June 1, 1984

HOPE CREEK GENERATING STATION
DOCKET NO. 50-354
DRAFT SAFETY EVALUATION REPORT
OPEN ITEMS

Pursuant to your letter dated March 5, 1984, which transmitted the Hope Creek Draft Safety Evaluation Report (SER), enclosed for your review and approval (see Attachment 2) are the resolutions to those Draft SER open items listed in Attachment 1.

FIGURE 4.6-10

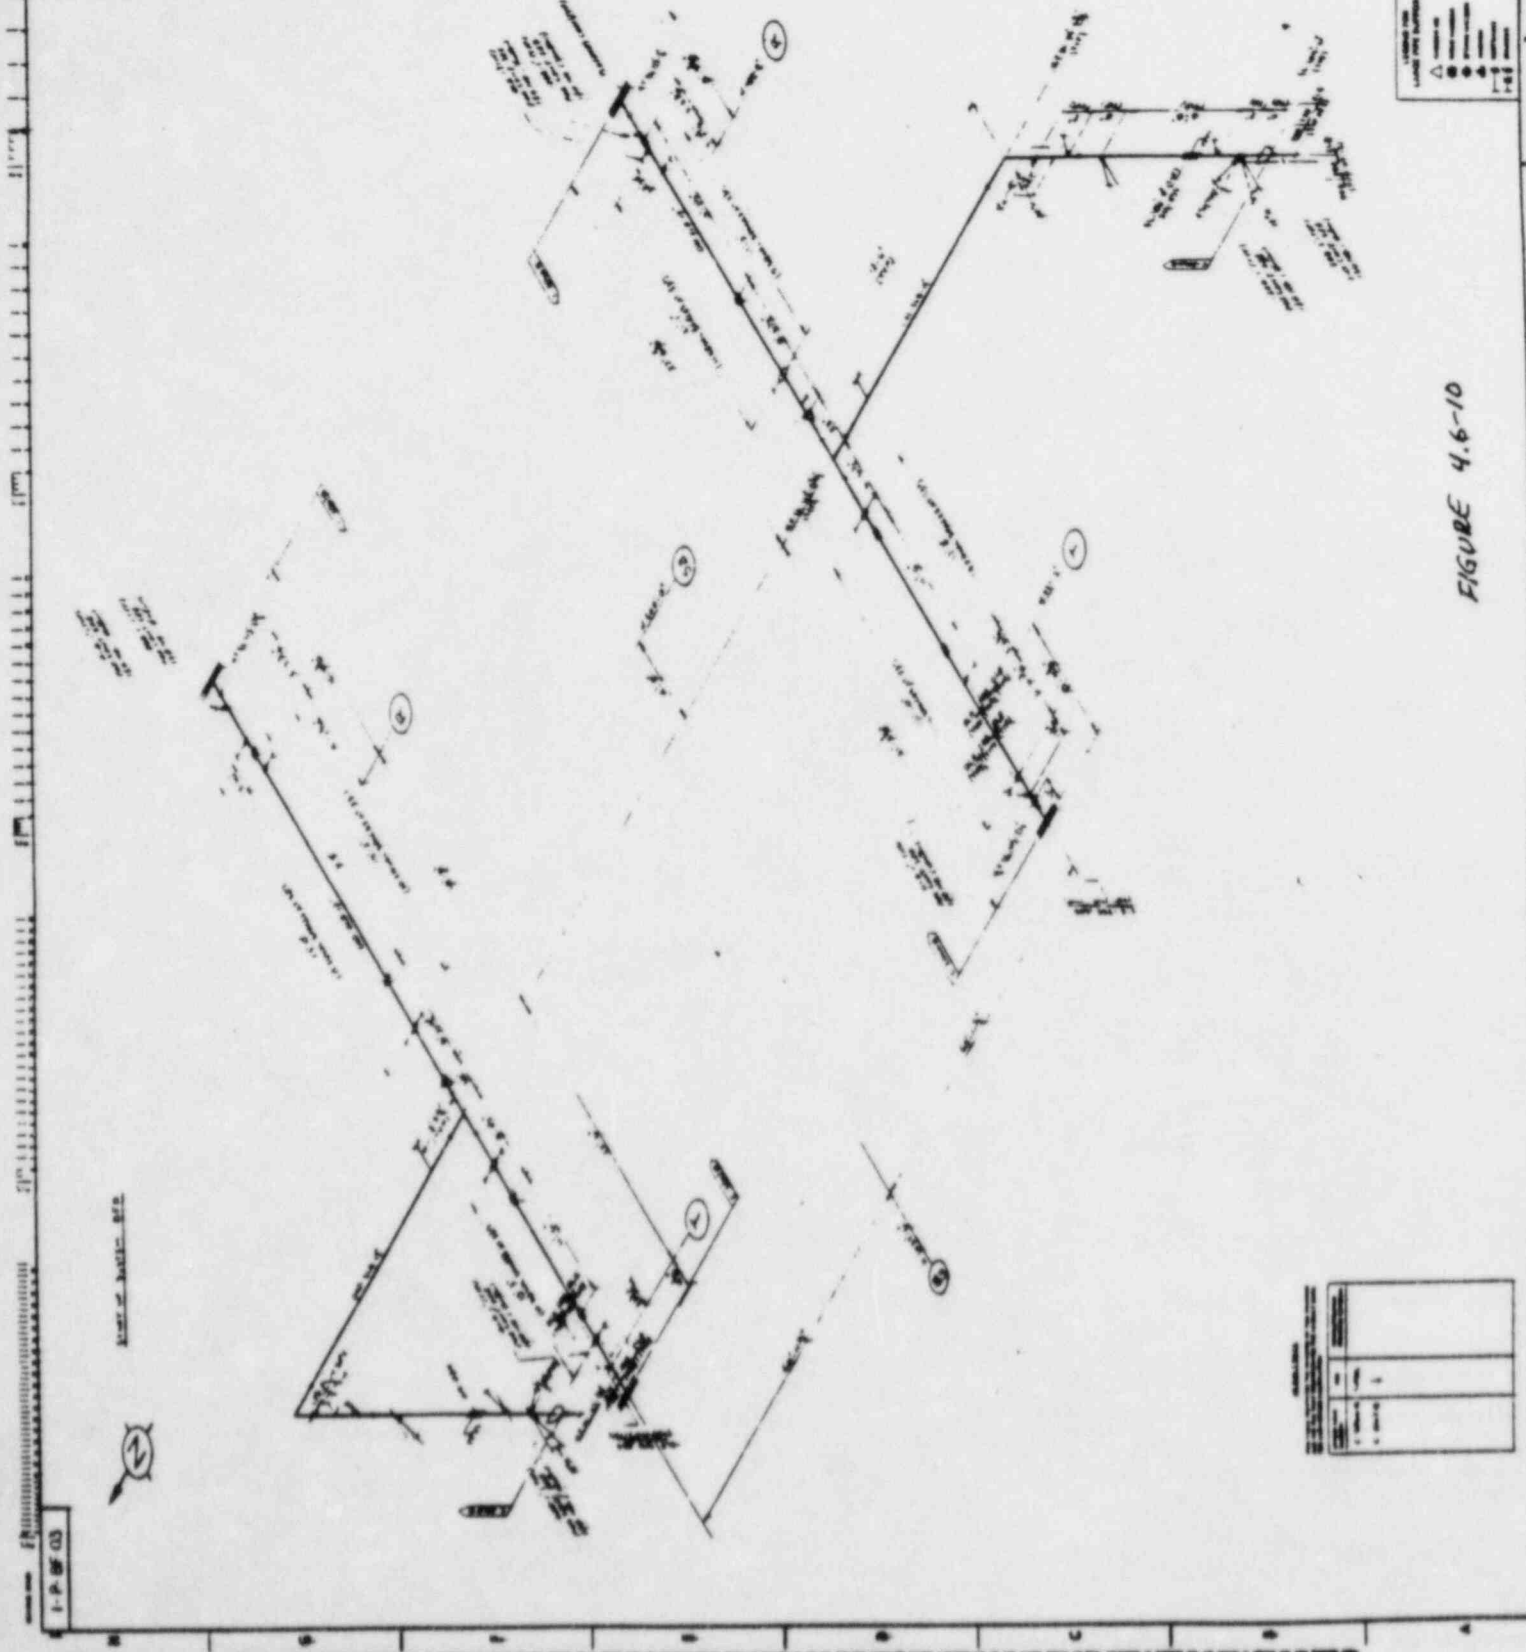
DSER OPEN ITEM 110b

The header piping slopes to a low point with a minimum pitch of 1/8 inch per foot as shown on Figure 4.6-10.
